AGENDA
CITY OF GLENWOOD SPRINGS
SPECIAL CITY COUNCIL MEETING
JULY 29, 2021
101 W. 8TH STREET
6:00 PM

City Council
STAFF REPORT
City of Glenwood Springs
July 29, 2021

Agenda Item: 09-20 Consideration of an Annexation and the initial zoning/Rezoning of 15.818 acres to Commercial (CO) District and Planned Unit Development (PUD) District at 214 Center Drive (PIN: 2185-061-00-042).

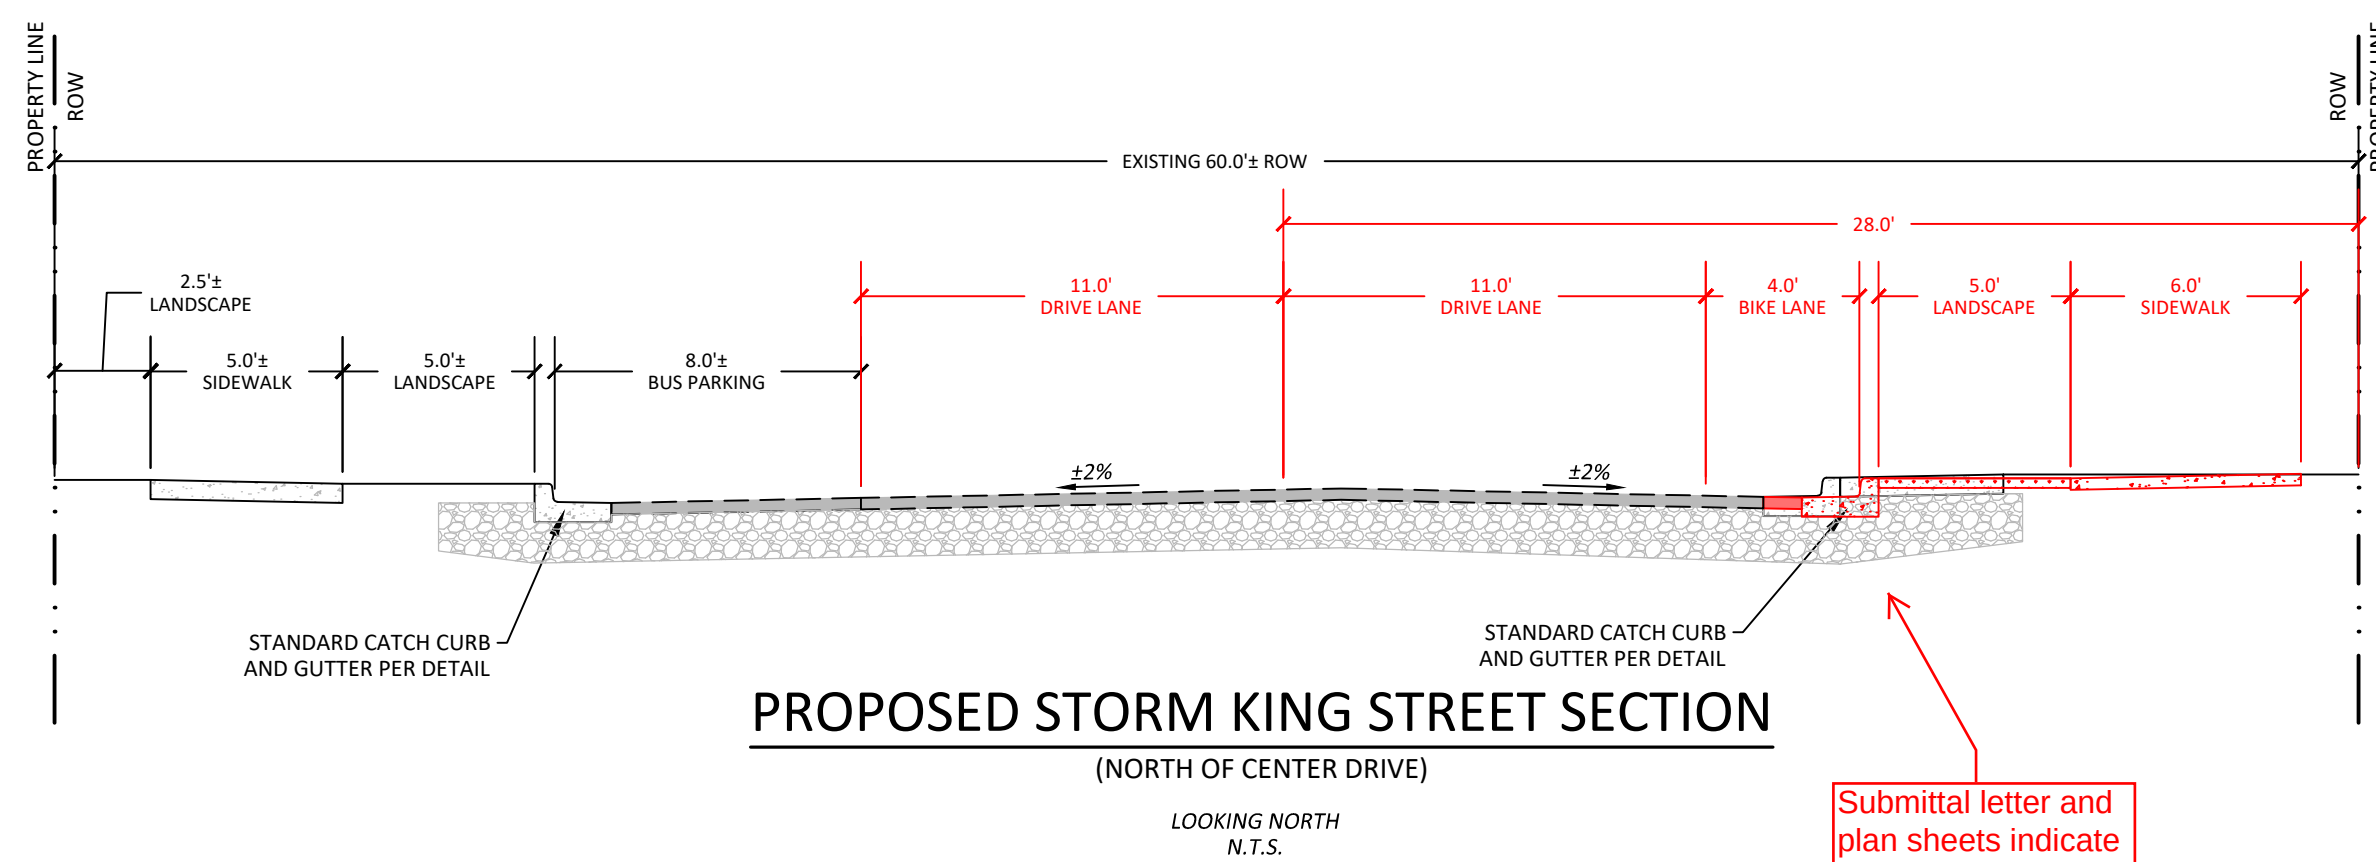
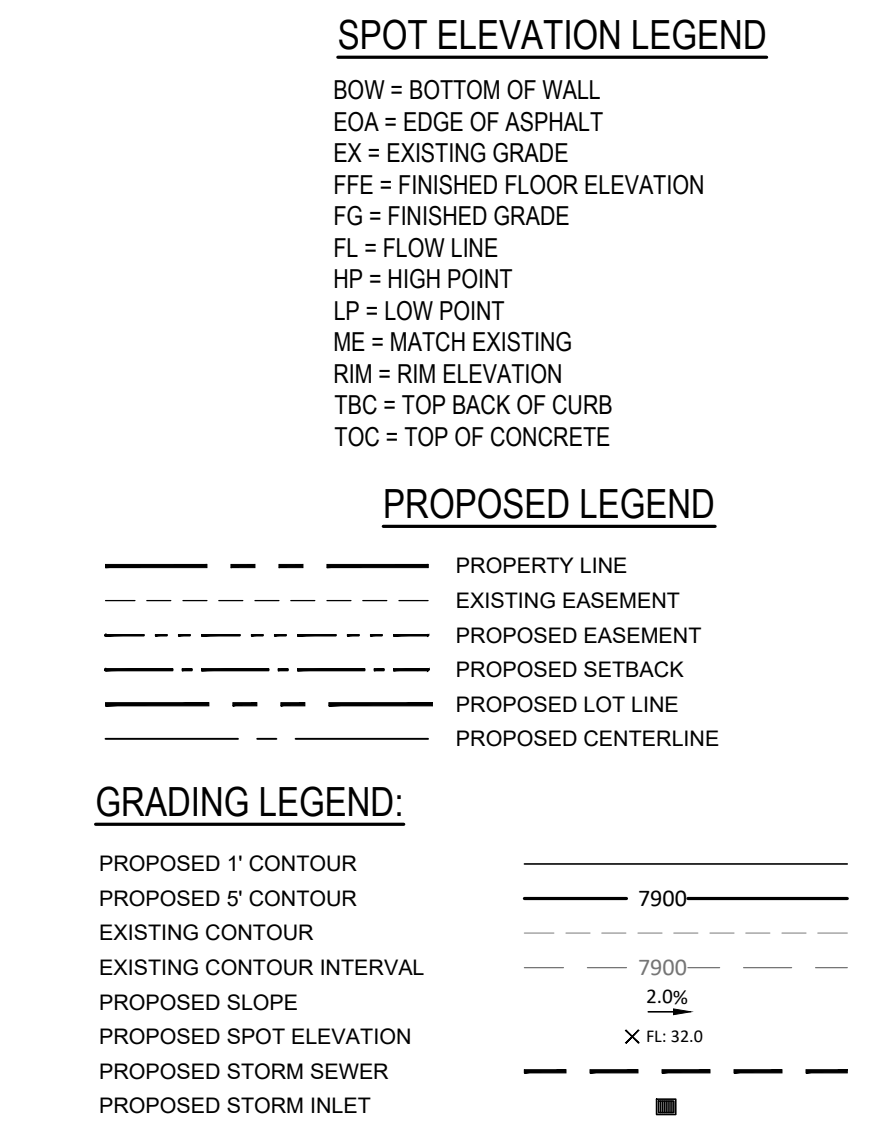
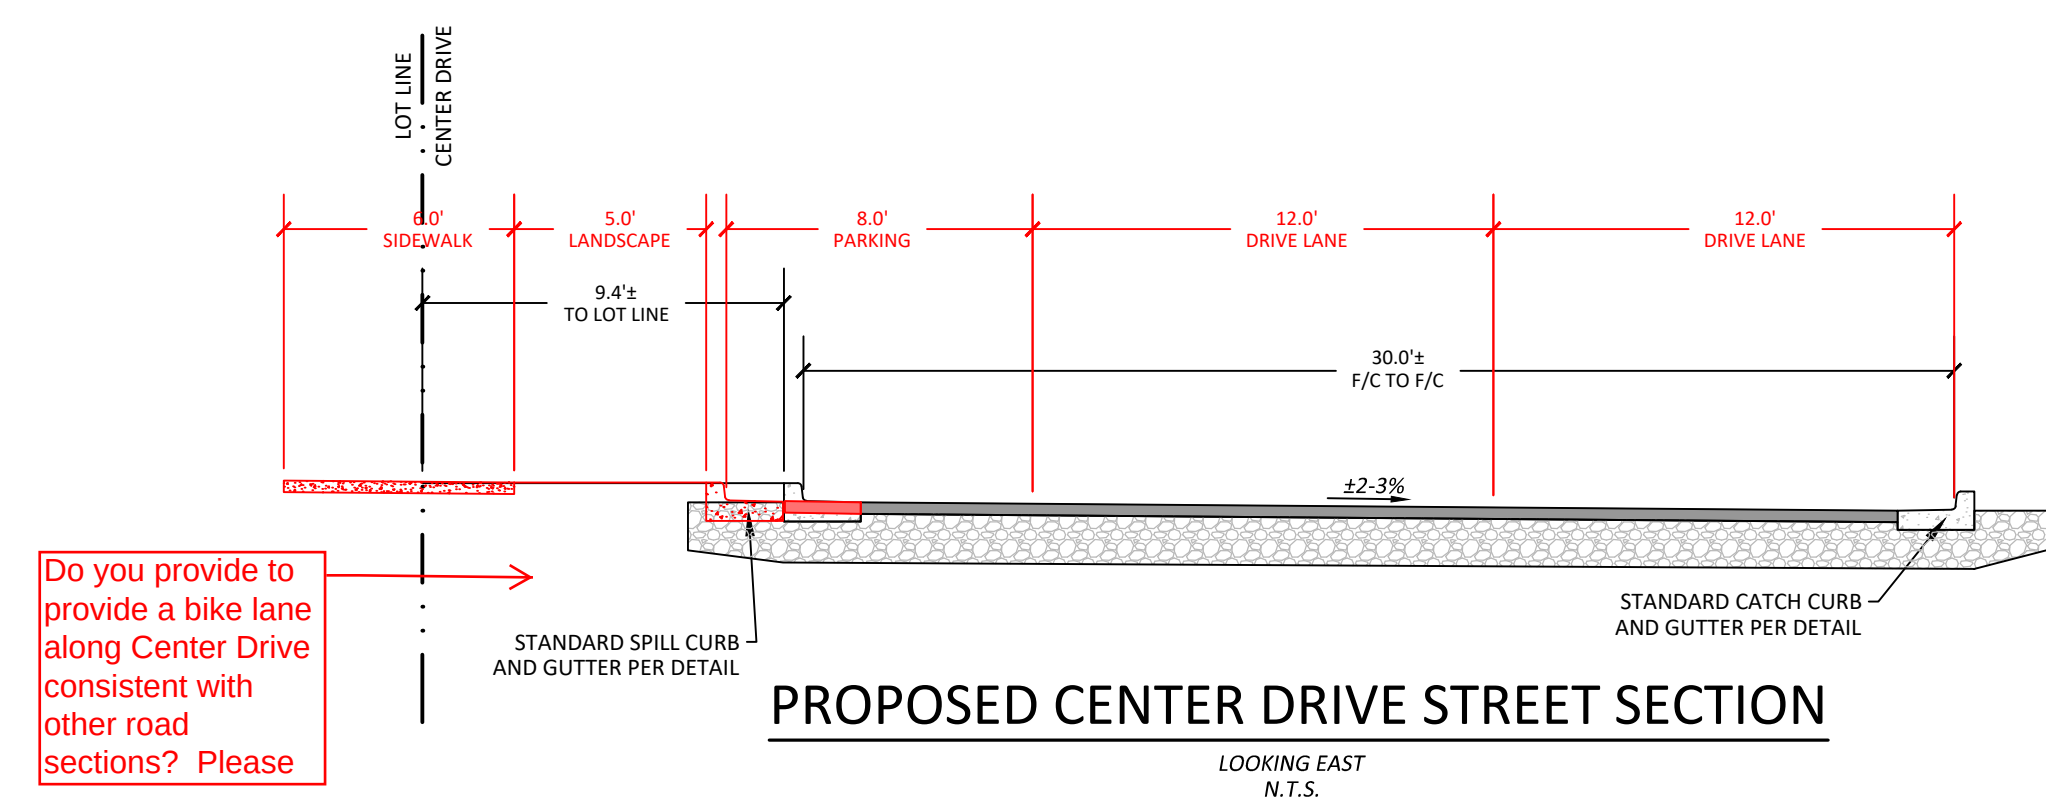
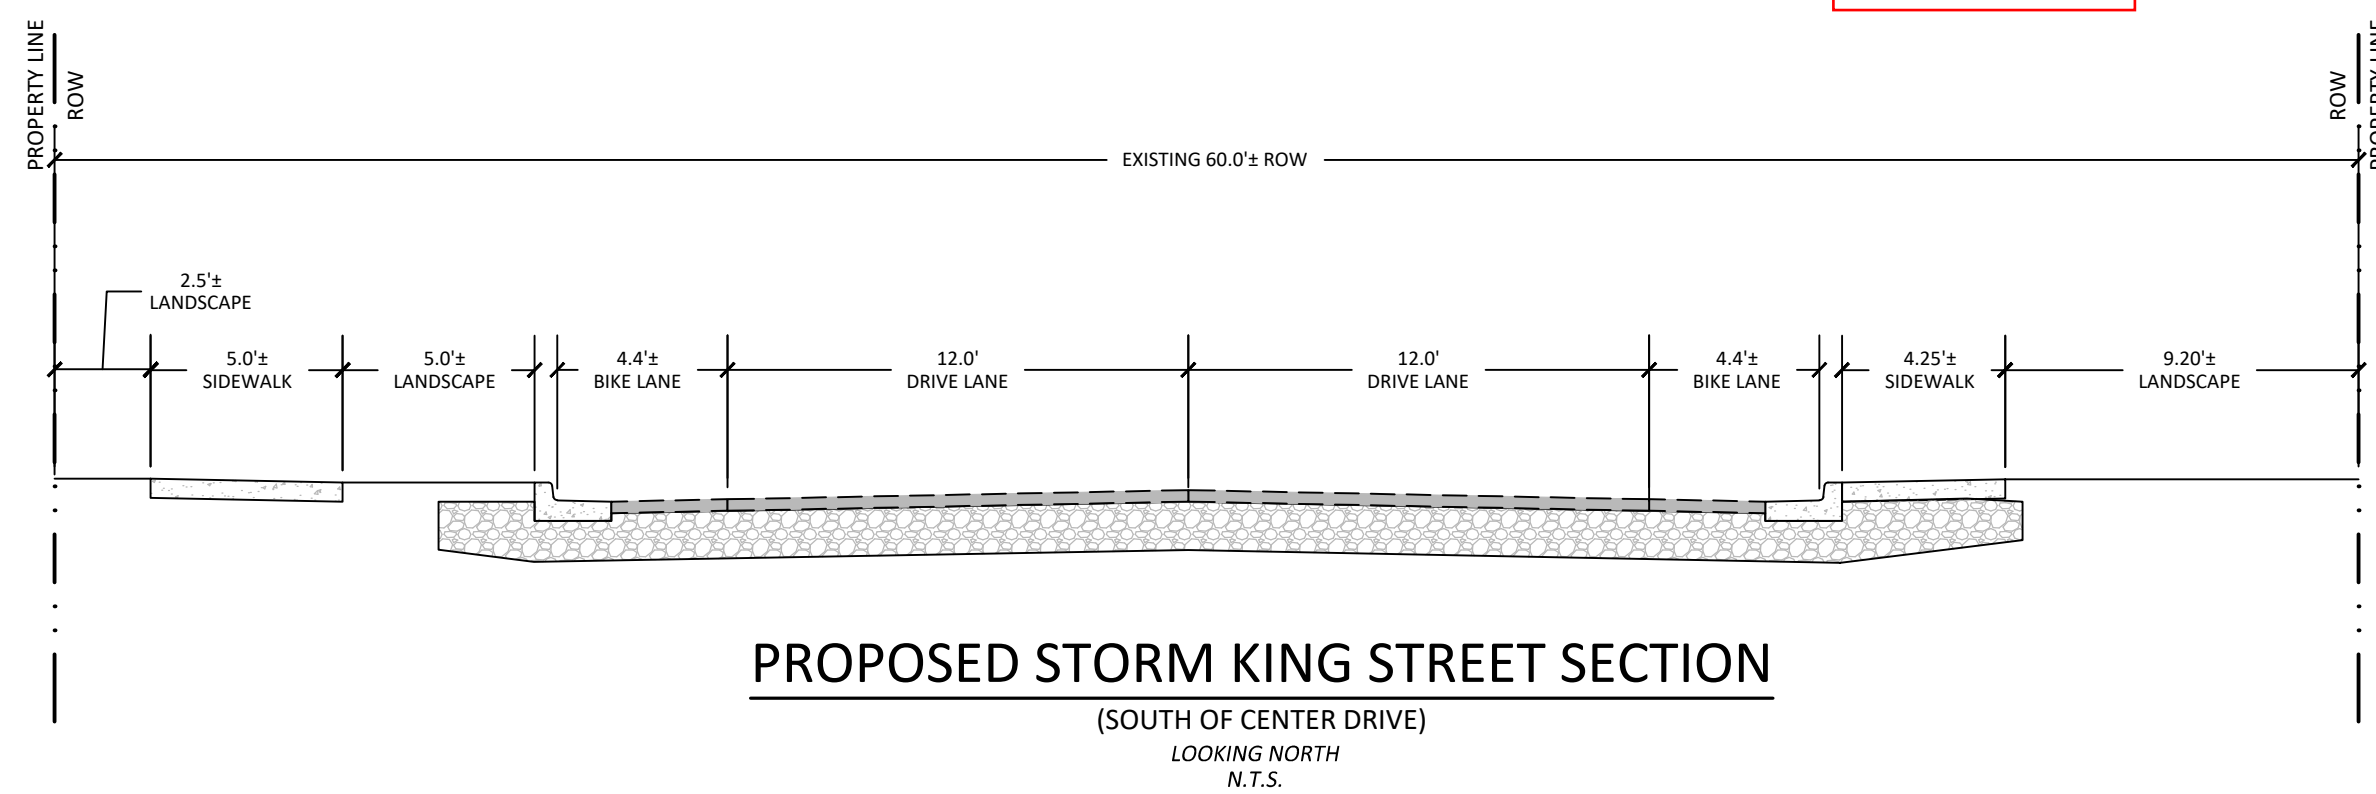
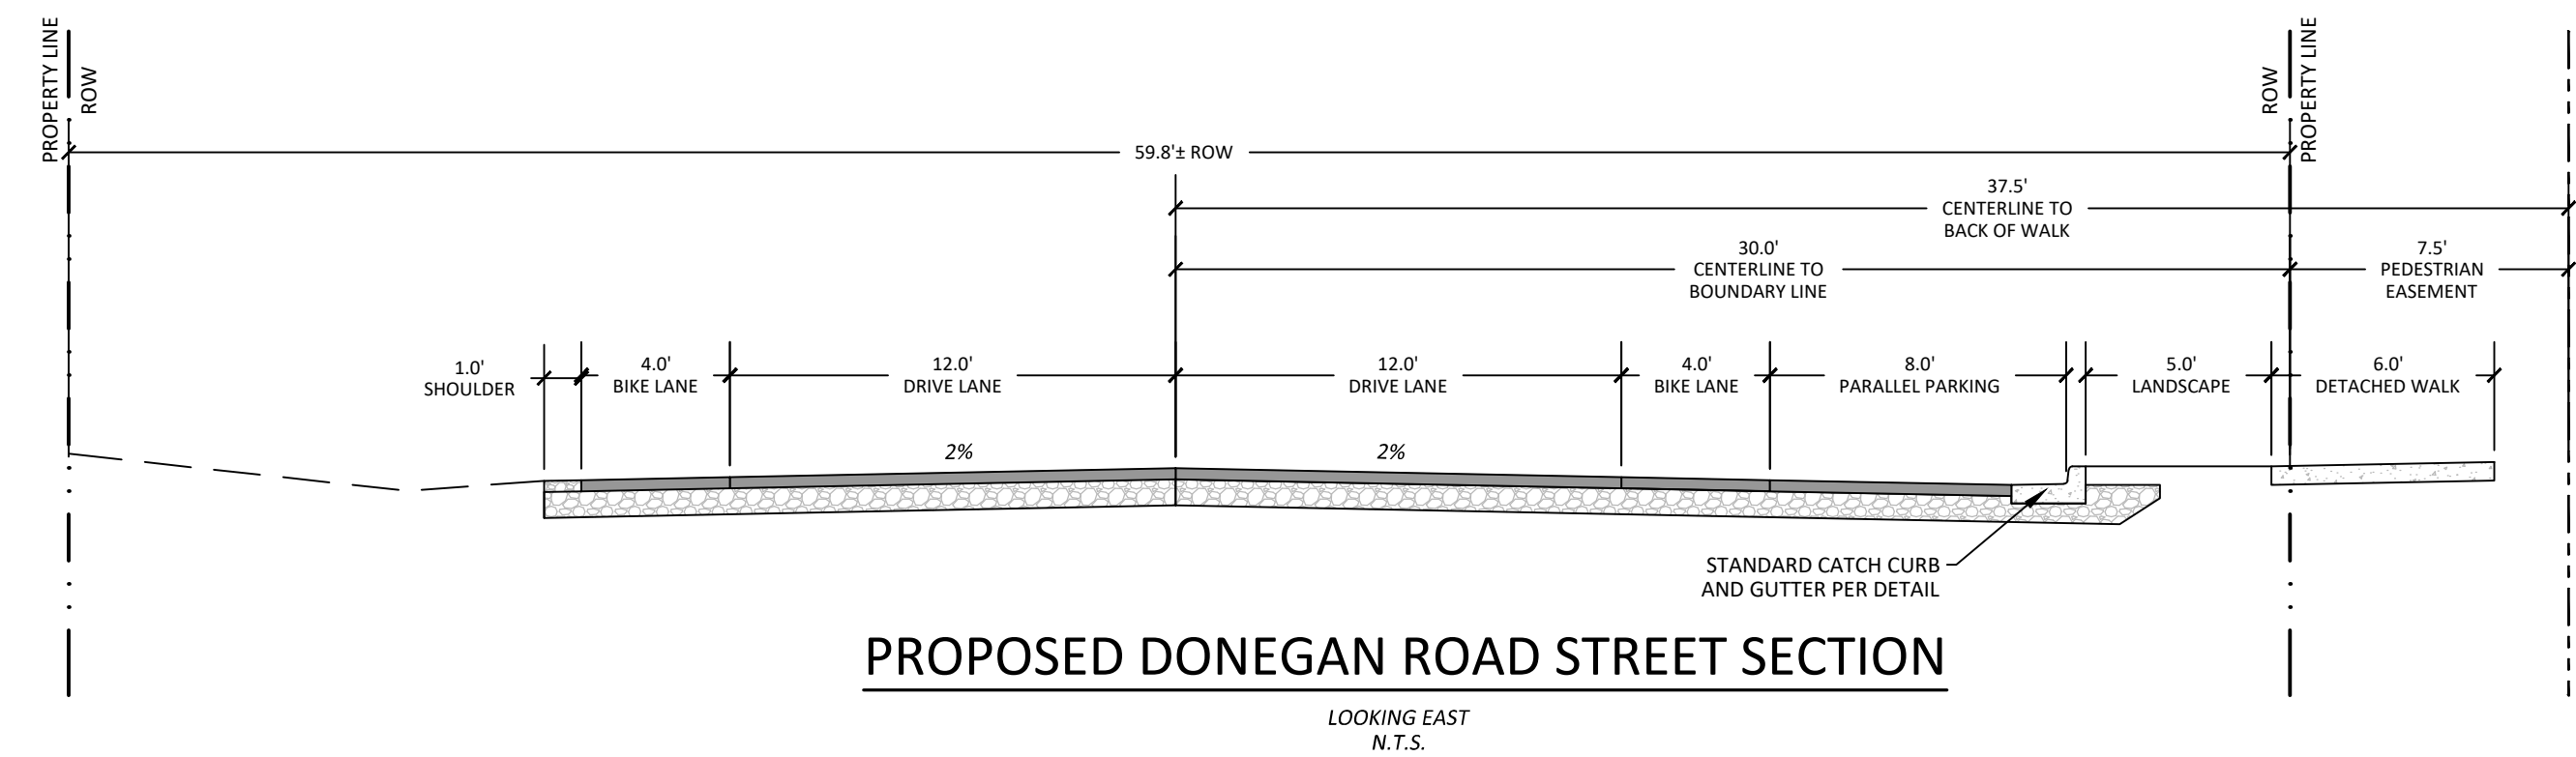
Please call out the width of this drive aisle.

Submittal letter and plan sheets indicate parking along Storm King. Please revise.

I recommend adding representative landscaping to all of the buffers depicted on the typicals provided.

Do you provide to provide a bike lane along Center Drive consistent with other road sections? Please
